# UNITED STATES PATENT AND TRADEMARK OFFICE

APPLICATION NO.	FILING DATE	FIRST NAMED INVENTOR	ATTORNEY DOCKET NO.	CONFIRMATION NO.
09/909,835	07/23/2001	Hiroyuki Tanaka	N36-134375M/TH	2206

# Office Action Summary

### **DETAILED ACTION**

5,631,992

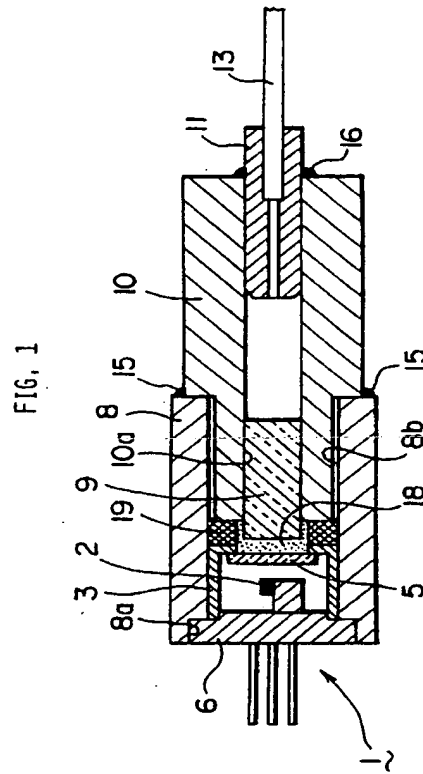
Claims 1, 3, 4, 6, 7, 9, 10, 11, and 14 are rejected under 35 U.S.C. 102(b) as being anticipated by Takahashi U.S. Patent No. 5,631,992 (~~newly cited~~). Refer to the appropriate drawings or parts of the specification. Takahashi discloses an optical fiber LED assembly with all the limitations of the abovementioned claims. Regarding claim 1, Takahashi discloses an optical module (figure 1) comprising: an optical semiconductor element (2) sealed with a cap (3) having an upper surface formed with a window (not labeled); at least one optical part (9) confronted with the window; a housing (10) holding the optical part therein and having an opened end face (toward the cap side) wherein an

outer dimension of the opened end face of the housing is equal to or smaller than an outer dimension of the upper surface of the cap; and a connecting layer (18) directly connecting the upper surface of the cap to the opened end face of the housing.

Takahashi's disclosure shows that the semiconductor element has a stem portion (6) opposite from the upper surface of the cap, and the outer dimension of the opened end face of the housing is equal to or smaller than an outer dimension of the stem portion, wherein the stem portion is distanced from the opened end face, as explained in instant claims 3 and 4. As to claim 6, Takahashi discloses that the housing has a receptacle part adapted to receive a mating optical plug (11). Takahashi's disclosure also shows that the module has a casing (8), which at least partly covers the cap and the housing; and which extend across the connecting layer as explained in claim 7. With reference to claim 9, Takahashi discloses an optical module in which an optical semiconductor element (2) of the cap sealing (3) type is mounted on (10) a housing to be aligned with an optical axis of at least one optical part (9) contained in the housing, wherein: an upper surface of the cap (not labeled) of said optical semiconductor element is bonded to an end face of said housing (by 18). Regarding claim 10, Cook discloses an optical module in which an optical semiconductor element (2) of the cap sealing type (3) is mounted on a housing (9) to be aligned with an optical axis of a lens (9) contained on the housing adapted to fittingly receive and hold a ferrule (11) of an optical plug of an mating connecting member, wherein: an upper surface of a cap of said optical semiconductor element is bonded to an end face of said housing. Takahashi further

discloses that a side surface of the cap is partly covered with a casing (8) and a clearance therebetween is sealed with resin (19), as mentioned in claims 11 and 14.

Applicant argues that Takahashi reference does not teach a housing "directly connected" to the cap, because the housing is connected to the cap through a seal ring made of synthetic rubber. However, Applicant's claim only calls for a "connecting layer directly connecting the surface of the cap to the open end face of the housing."

Interpreting the claim language in light of the specification, the rubber layer in Takahashi "directly connects" the cap and the housing in the same way that the adhesive layer does in the present invention. Both are layers disposed directly between the cap and the housing; therefore, the rubber layer of Takahashi "directly connects" the cap to the housing. If the reference showed another layer (in addition to the rubber) disposed between the cap and the housing, the rubber would not "directly connect" the two.

Applicant further asserts that the Takahashi reference does not show "the outer diameter of the housing is equal to or smaller than the diameter of the cap". Rather, the claim simply requires a "housing...having an opened end face wherein an outer dimension of the opened end face of the housing is equal to or smaller than the outer dimension of the upper surface of the cap...". Referring to the figure below, one can clearly see that the opened end face of the housing (not labeled, but holding the rod lens 9 therein) has a smaller outer dimension than the upper surface (not labeled) of the cap (3).
